CIR Response

CIR #19

Carleton Place Arena
Renovation and Addition

SITE INSTRUCTION NO. ME-07 MECHANICAL AND ELECTRICAL

1 MECHANICAL ROOM (EXISTING)
MSK1 SCALE: 1/4" = 1'-0"

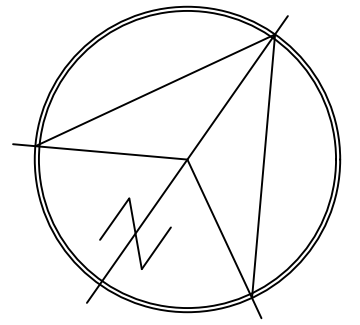
M7.1 SKETCH MSK-1 – REVISION 1:

Indicates new location of Water Storage Tank and approximate location of new Floor Drain in existing Mechanical Room.

E7.1 SKETCH MSK-1 – REVISION 1:

Indicates new location of Electrical Panel and Transformer.

1 GROUND FLOOR PLAN
FA2 SCALE: 3/32" = 1'-0"

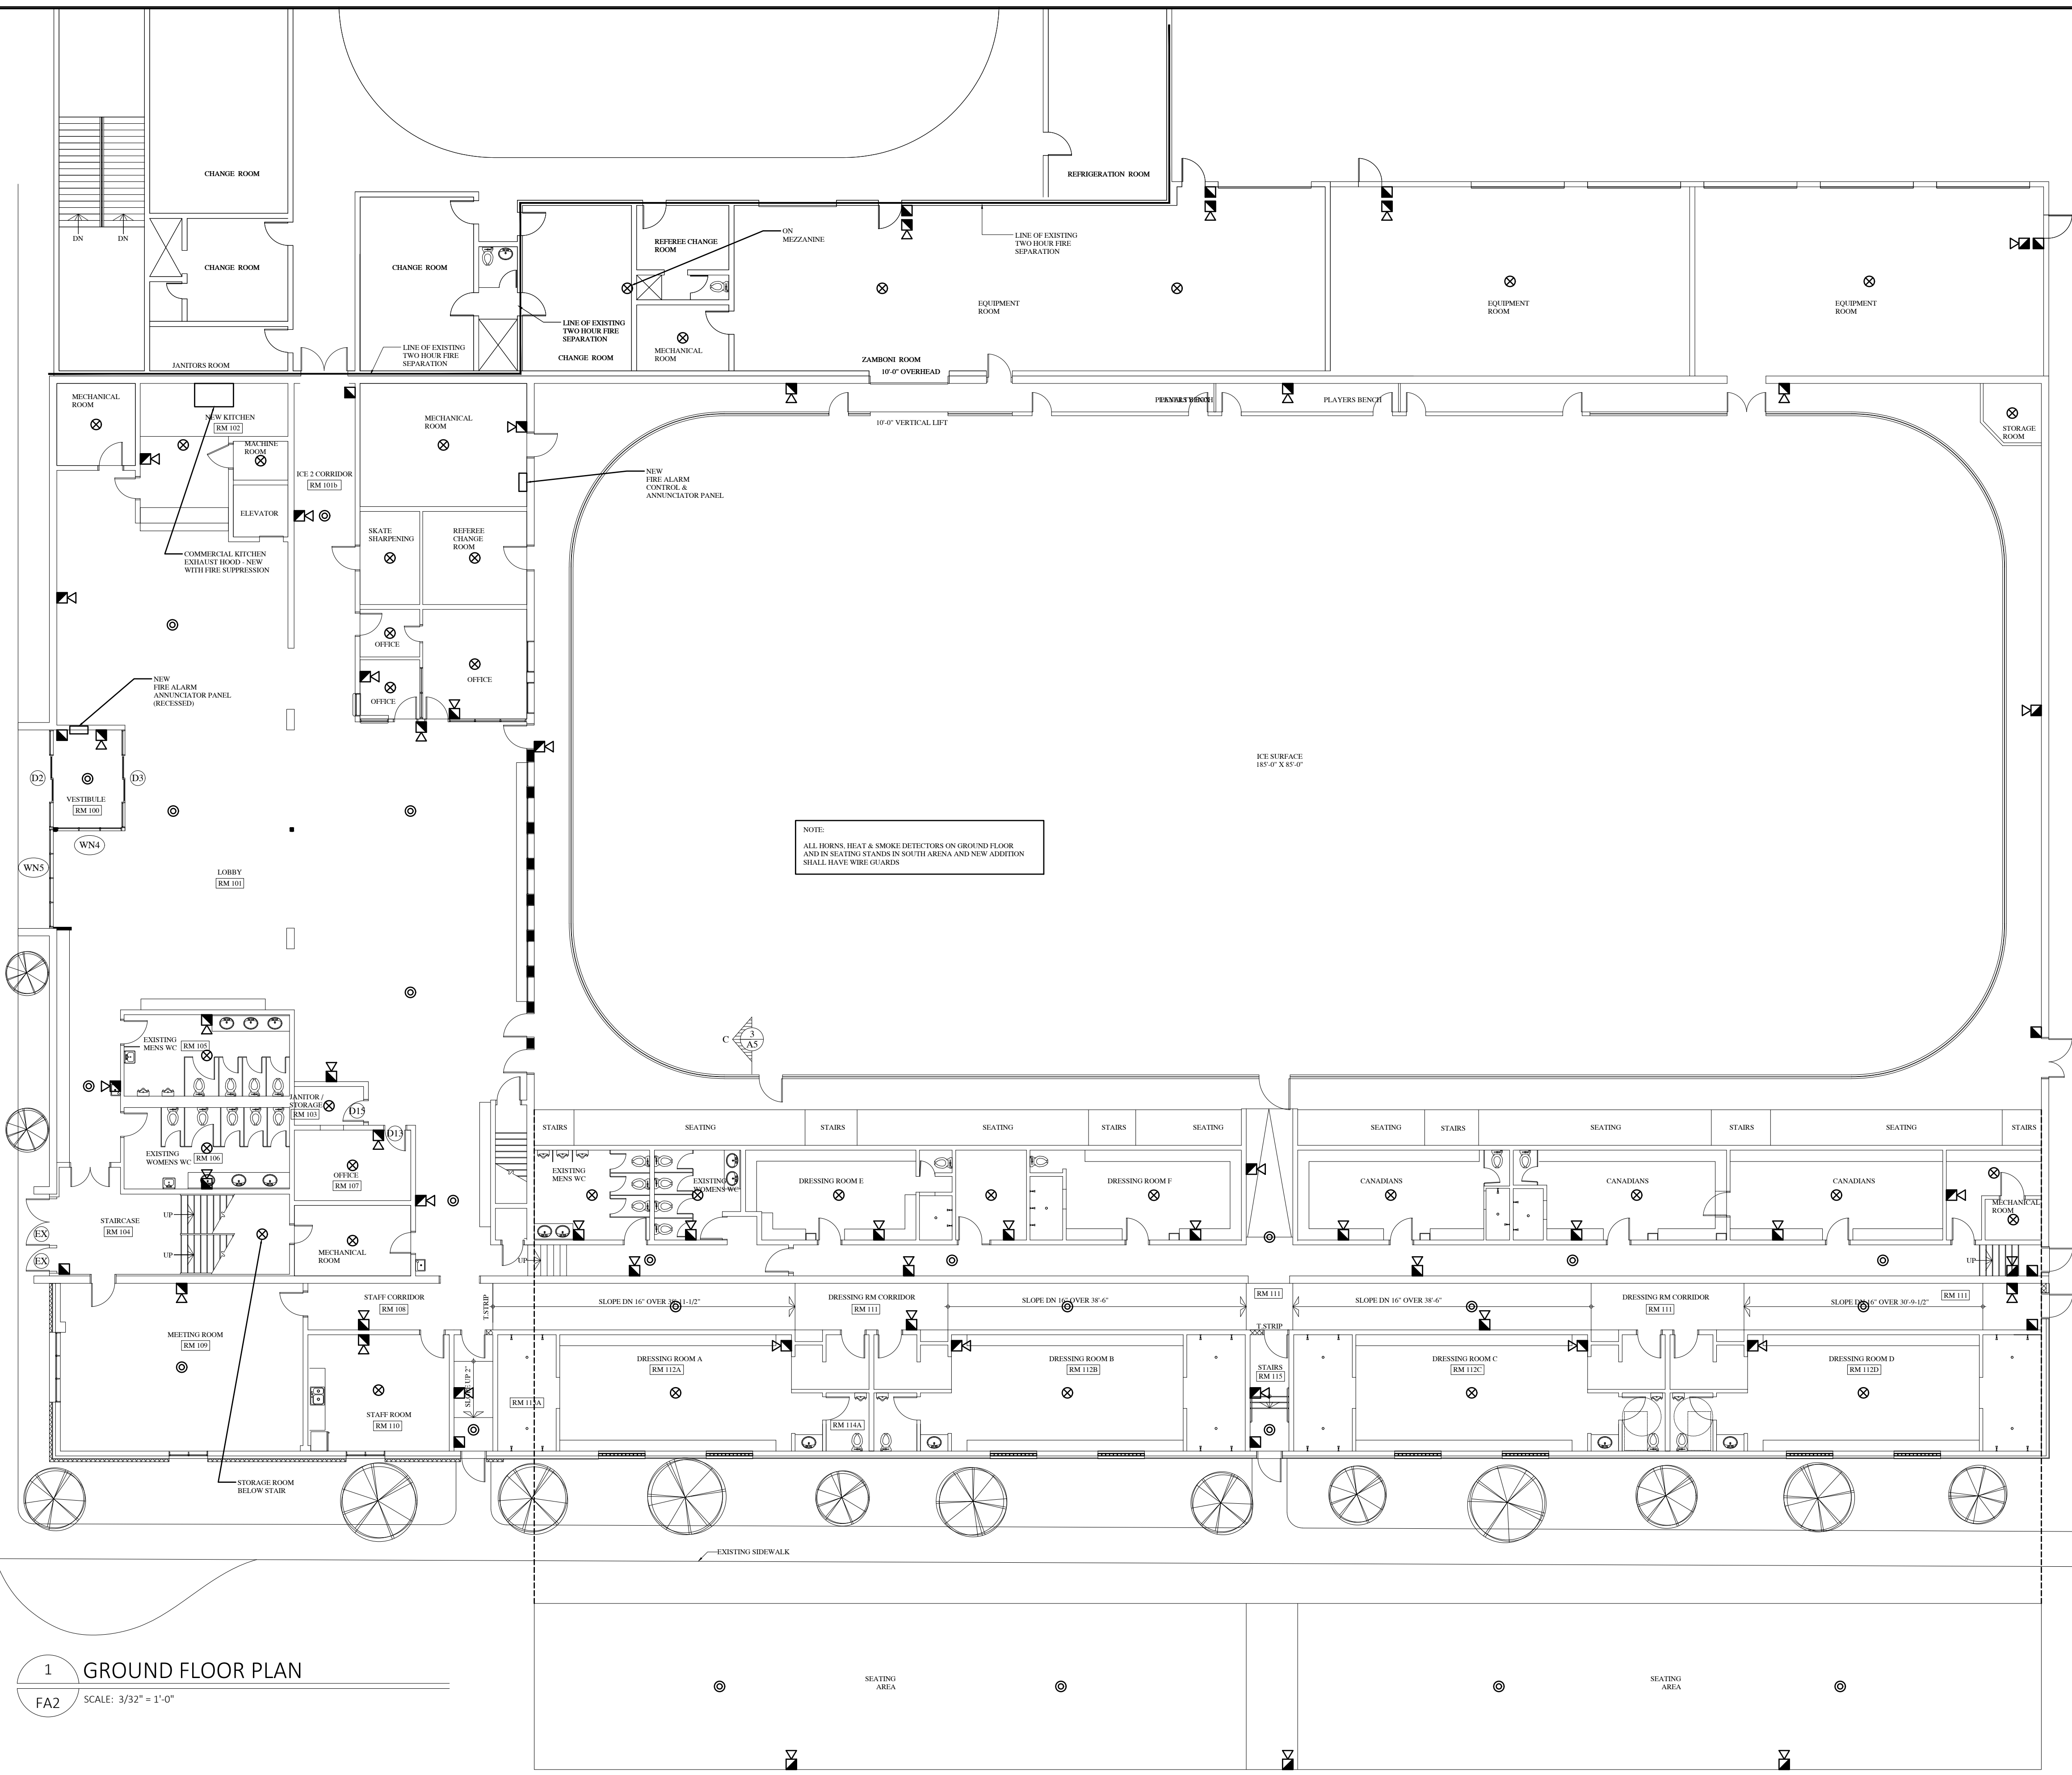
1. To maximize the decibels and light output, our electrical contractor in correlation with their Fire Alarm sub-trade are proposing to install several horn and strobes on the ceilings instead of on walls, the areas where we propose this devices ceiling mounted are as follows:
 - Dressing rooms E, F and Canadians
 - Existing washrooms under the stands
 - Mechanical rooms under the stands
 - Lobby area
 - Washrooms in lobby area
 - Offices in lobby area
 - Office room 107
 - Existing hall on 2nd floor
 - Corridor rm 200

2. Their Fire Alarm tech also noticed that there are smoke detectors above the seating area on the arena. They have advised that smoke detectors cannot be installed in an unheated area as these devices will not work. We have referenced the ULC and building code 3.4 and did not see a requirement for detectors in a seating area of an arena.

Is there a code requirement that we have missed? please provide if we have missed it; otherwise, we would recommend removing these devices.

E7.2 DRAWINGS FA1 & FA2 – REVISION 1:

.1 The following items have been deleted from the list in the M&E Addendum:

.1 South Arena Lobby:

1 – Smoke Detector in Lobby;

2 – Horns/Strobes in Lobby;

.2 South Arena Rink:

1 – Heat Detector in north Service and Storage Rooms;

2 – Horns/Strobes in north Service Rooms;

.3 South Arena Change Rooms:

1 – Smoke Detectors in Corridor.

.2 The following items have been added to the list in the M&E Addendum:

.1 South Arena Rink:

1 – Pull station at exterior door;
